St. Lucie Units 1 and 2
Docket Nos 50-335 and 50-389

RE: Reply to Request for Information - License Amendment Request
Station Battery Surveillance Requirement Changes

Enclosure
RAI Reply for License Amendment Request
Station Battery Surveillance Requirement Changes

Fig. 1 – Inter-Cell Connection & Measurement Detail

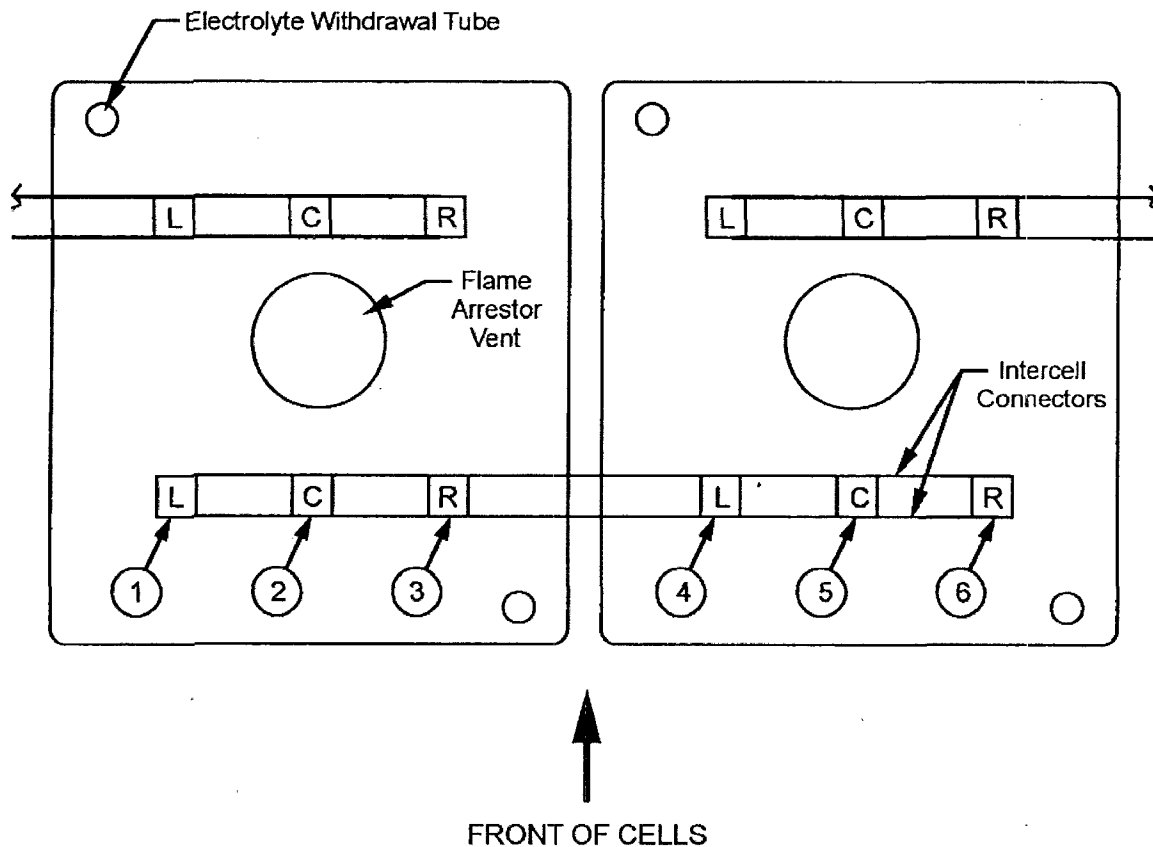
- a. Provide a list of all battery connections.
- b. Explain why Terminal connection resistance was deleted from the existing Unit 1 TS SR 4.8.2.3.2.c.3, and Unit 2 TS SR 4.8.2.1.c.3, and not re-inserted in the proposed TS Table on Page 3/4.8-11.
- c. Provide a typical drawing of the station battery cell connections arrangement showing all types of station battery connections.

The Inter-Cell connections utilize solid bus bars between two adjacent cells with bolted connections. Each cell has 3 positive posts and 3 negative posts, which are connected together in-series with the adjacent cells via bar connectors. Therefore, there are 6 bolted connections for each Inter-Cell connection (See Figures 1 & 6). While the 3 posts of each battery polarity connection are paralleled and should have the same resistance, IEEE 450 guidance states that measurements should be taken from the Left post of one cell to the Left post of the next cell, and are then repeated for Center to Center and Right to Right. Deviations between the Left, Center and Right post-to-post measurements can help indicate that one of the paralleled post to bus-bar connections is degraded.

1. Three measurements are required for each set of cells connected with intercell connectors.
 - ① to ④ - Left Post to Adjacent Cell Left Post
 - ② to ⑤ - Center Post to Adjacent Cell Center Post
 - ③ to ⑥ - Right Post to Adjacent Cell Right Post
2. See Figure 2 for measurements at a terminal detail connector (e.g., interstep cable connections.)

Fig. 2 – Inter-Tier (or Inter-Rack) Connection & Measurement Detail

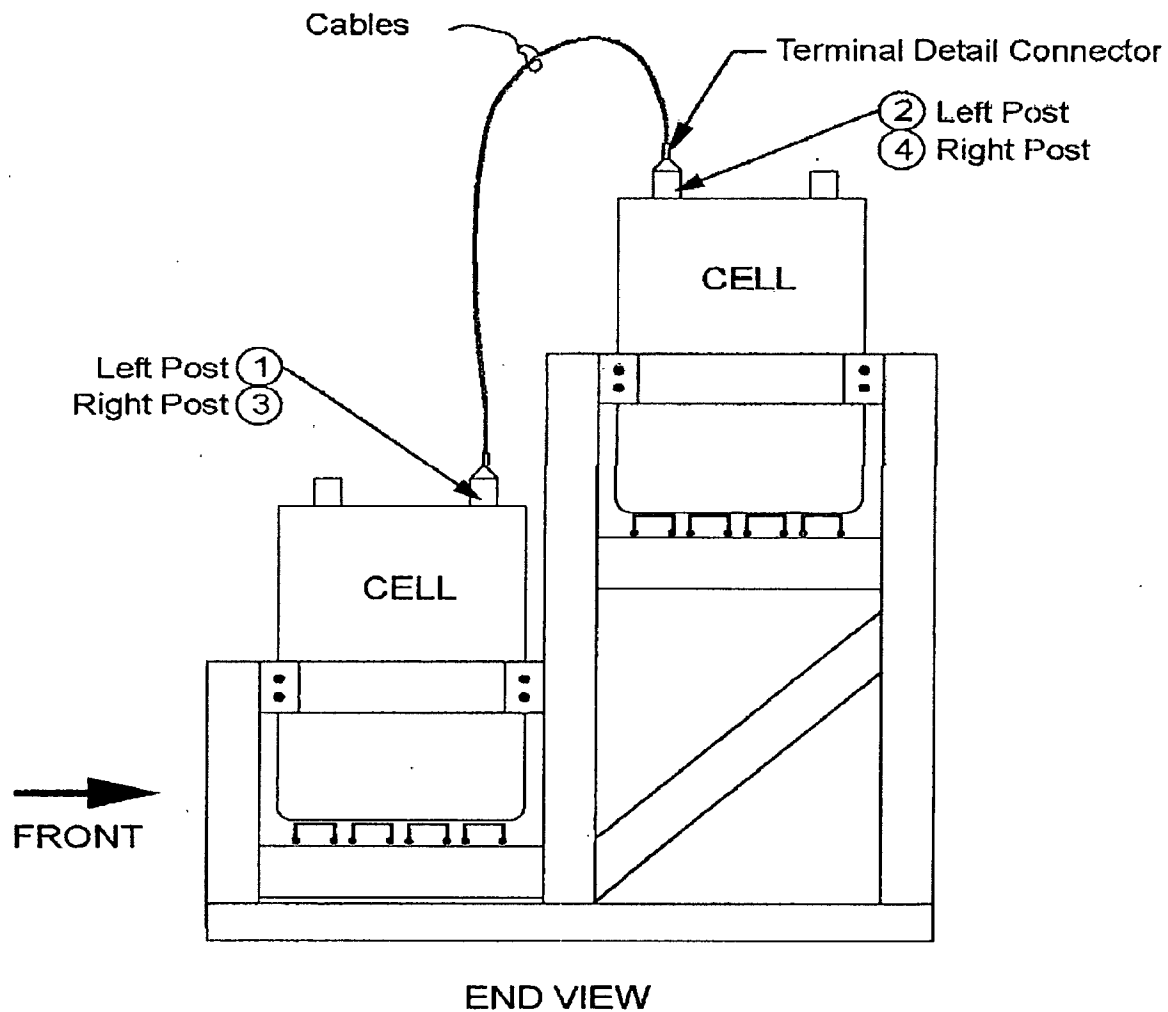
The Inter-Tier (& Inter-Rack) connections tie the battery cell from one section of the battery rack to the next cell (electrically in-series) located on the adjacent tier of the battery rack. These connections use Terminal plates, 500 MCM cables, and crimped cable lugs to jumper the two cells together. These plates are bolted to all three posts of each cell. Measurements from the Inter-Tier (& Inter-Rack) connections are done from the Left post of one cell to the Left post of the second cell and are repeated for the Right to Right. Note that as the plate envelopes and covers the Center post, that the Center post is not accessible and cannot be measured, as is done with the Inter-Cell connections, which remain accessible (See Figures 2, 4 & 5)

Two measurements are required,

Left Post of First Cell (1) to Right Post of Second Cell (4)

Right Post of First Cell (3) to Left Post of Second Cell (2)

Fig. 3 – Positive & Negative Output Terminals & Measurement Detail

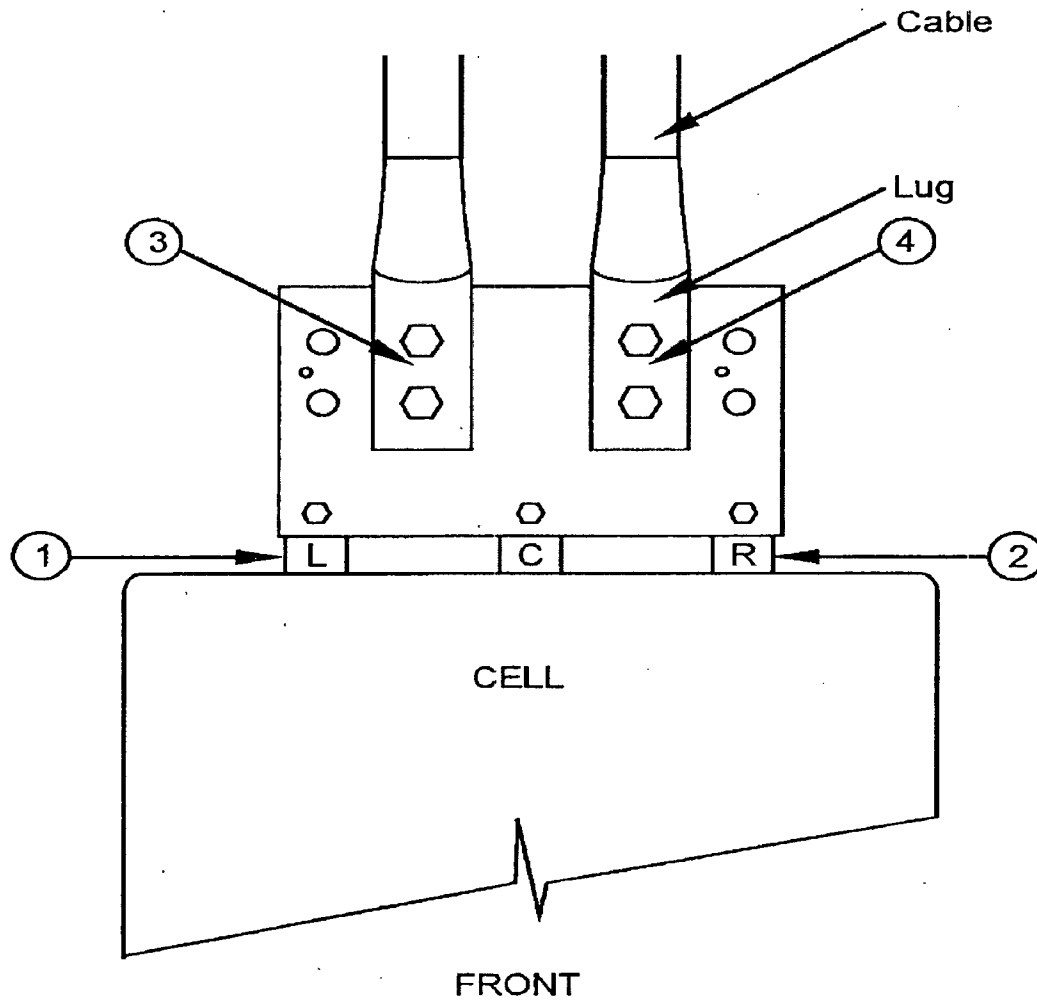
The Terminal Connections provide the battery output power (+/- 125VDC nominal) to the plant DC buses, and use Terminal plates, as used for the Inter-Tier (& Inter-Rack) connections. The Terminal measurements are taken from the Left post of the cell to the Right lug connected to the outgoing cable; and from the Right post of the cell to the Left lug connected to the outgoing cable (See Figures 3 & 4)

Two measurements are required,

① to ④ - Left Post to Right Lug

② to ③ - Right Post to Left Lug
